ADDENDUM NO. 3

**RE: NCDAC NC Correctional Institution for Women
Air Conditioning Installation
SCO ID#: 22-24913-02A
NCDAC Central Engineering Job Order # 4290**

DATE: September 12, 2023

MECHANICAL ENLARGED PLANS -
 FALCON, SPARROW BUILDINGS

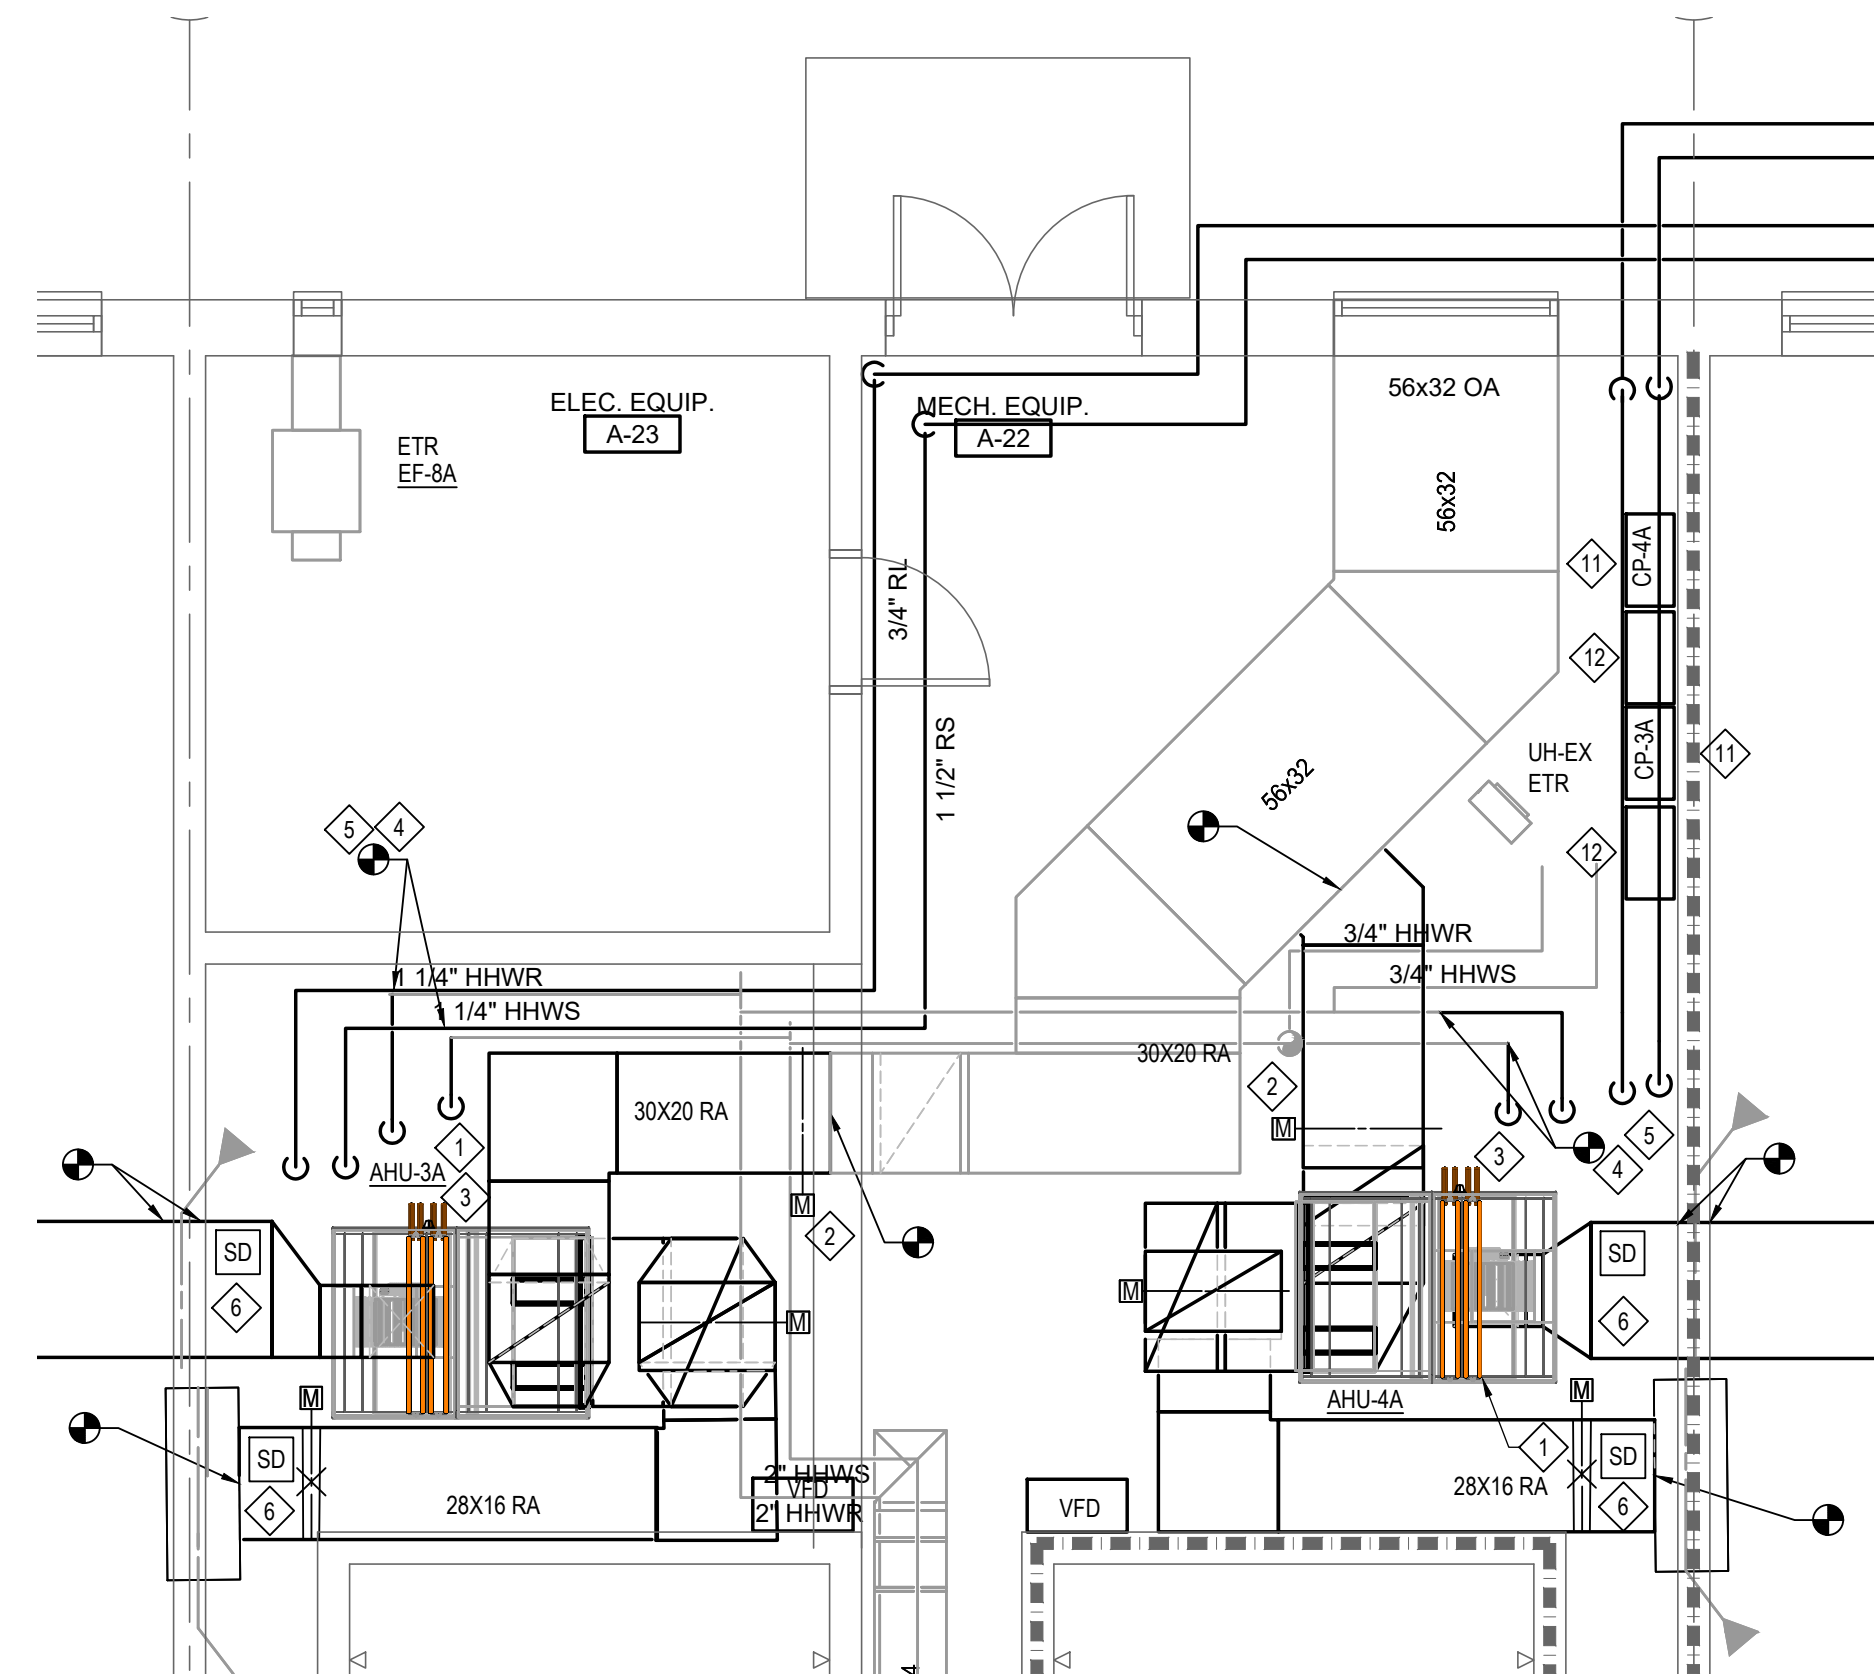
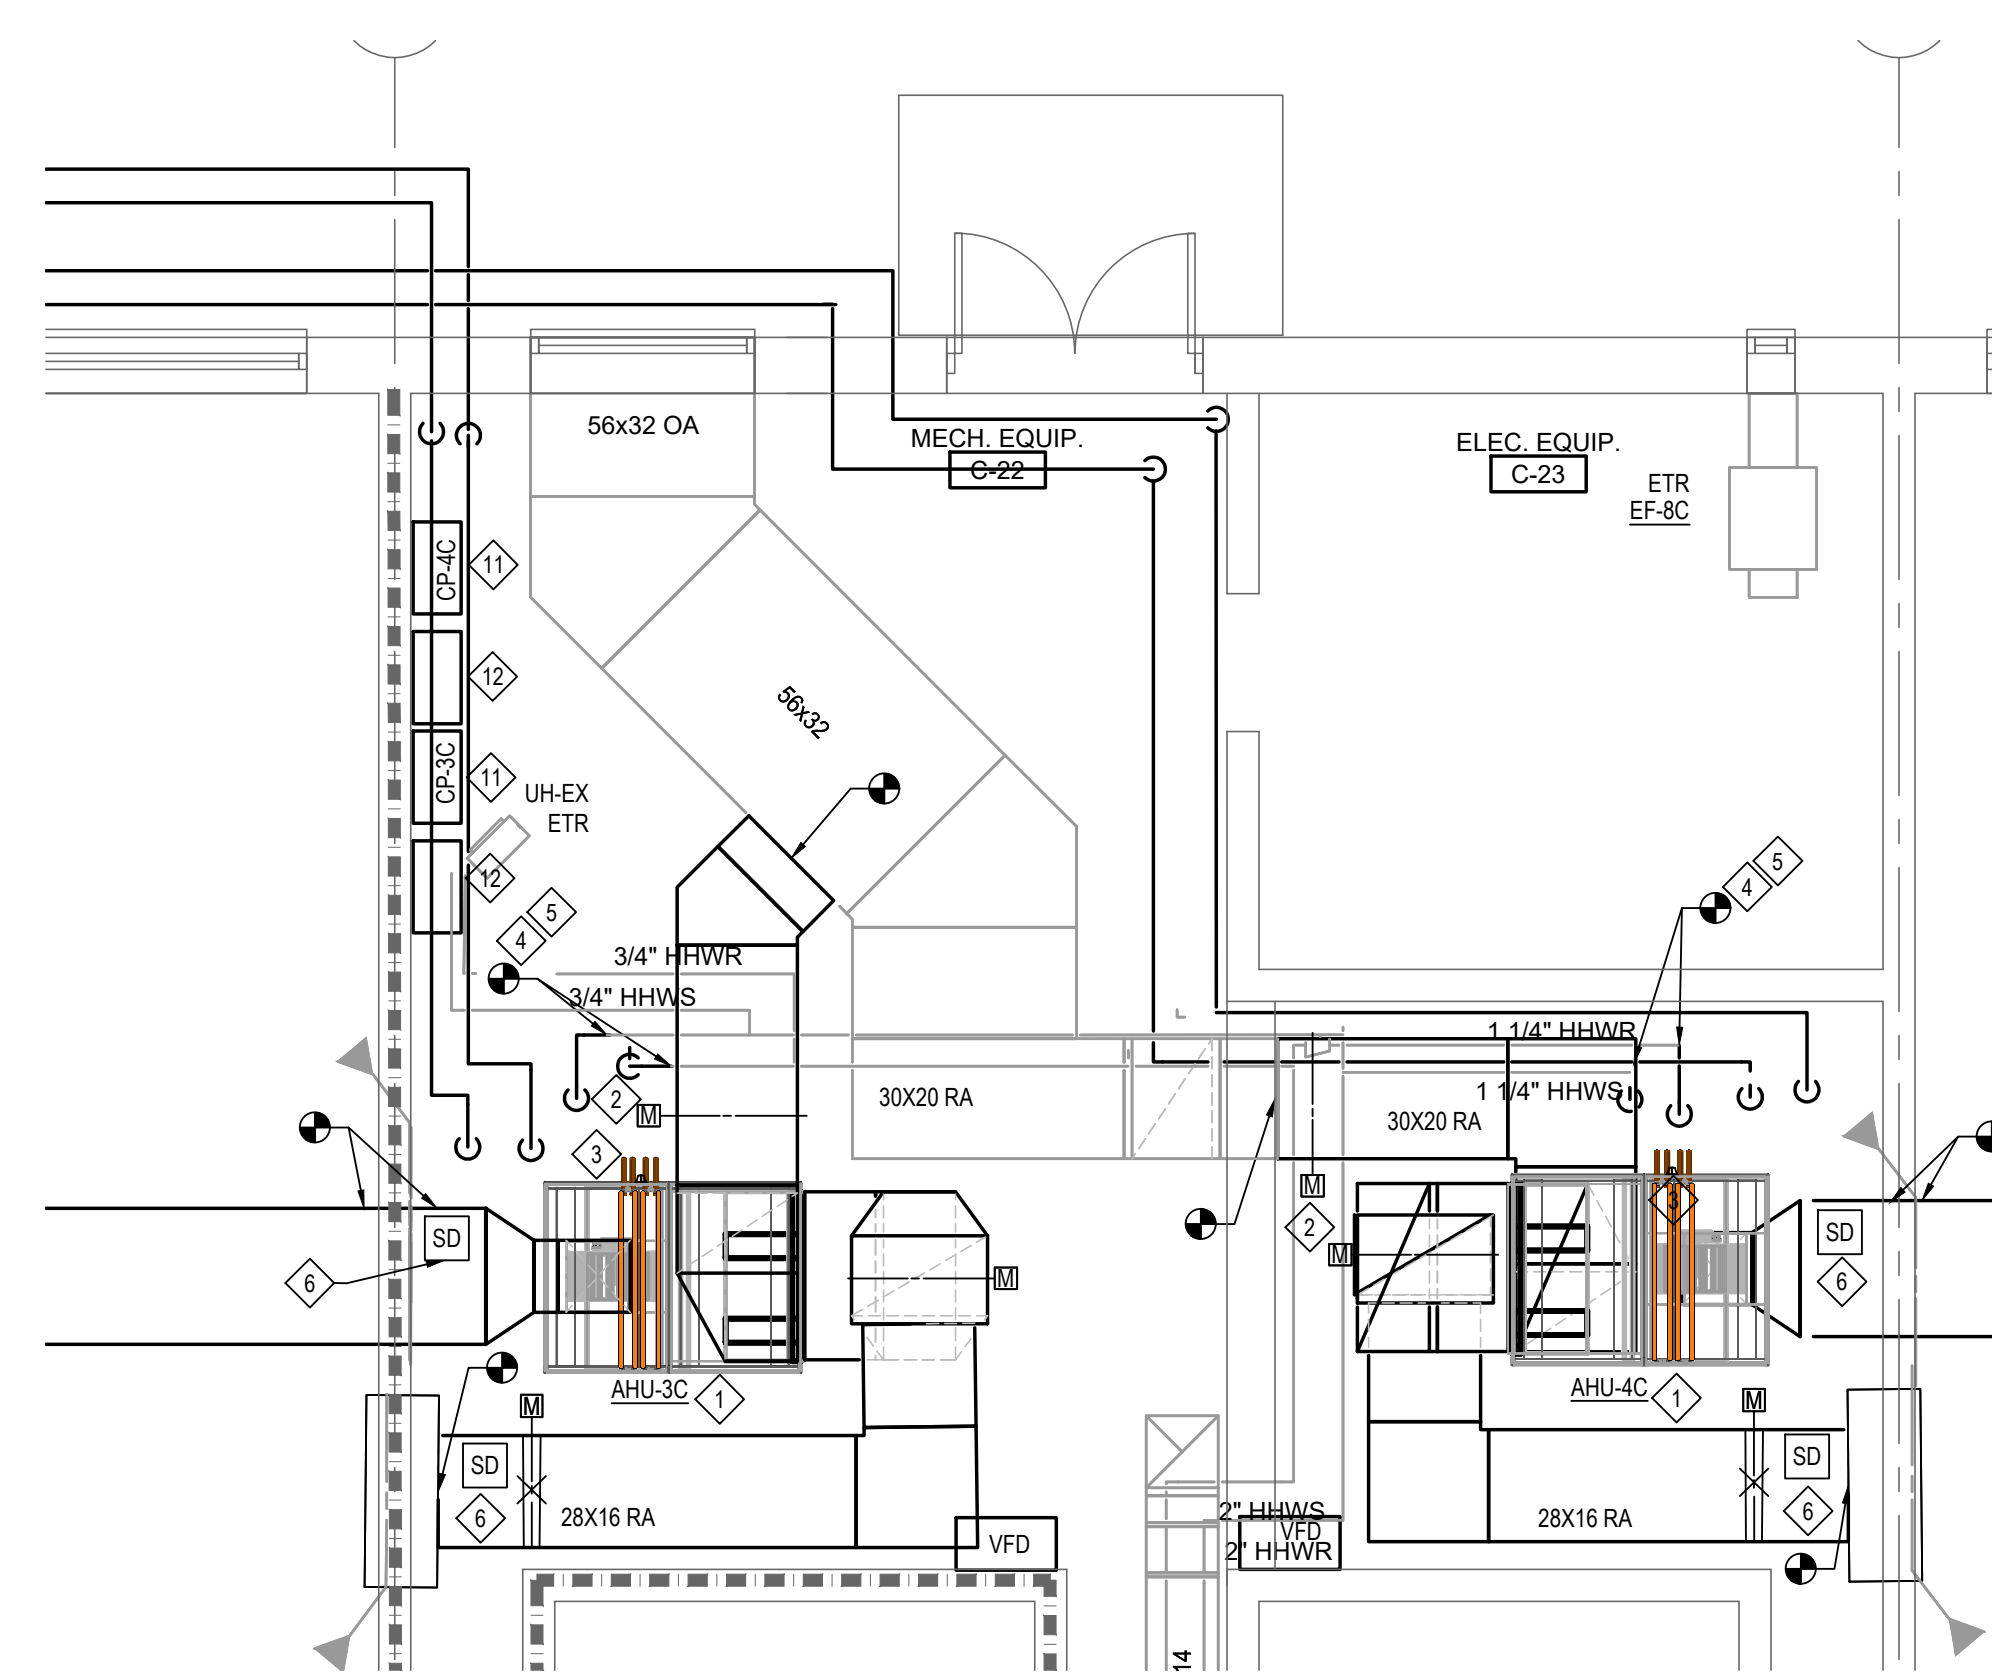
6. Sheet M220: Revised keyed note 1. See revision on attached sheet.
7. Sheet M401: Revised keyed note 6. See revisions on attached sheet.
8. Sheet M501: Revised ductwork detail. Exposed ductwork in dormitories shall be double wall insulated ductwork. See revision on attached sheet.
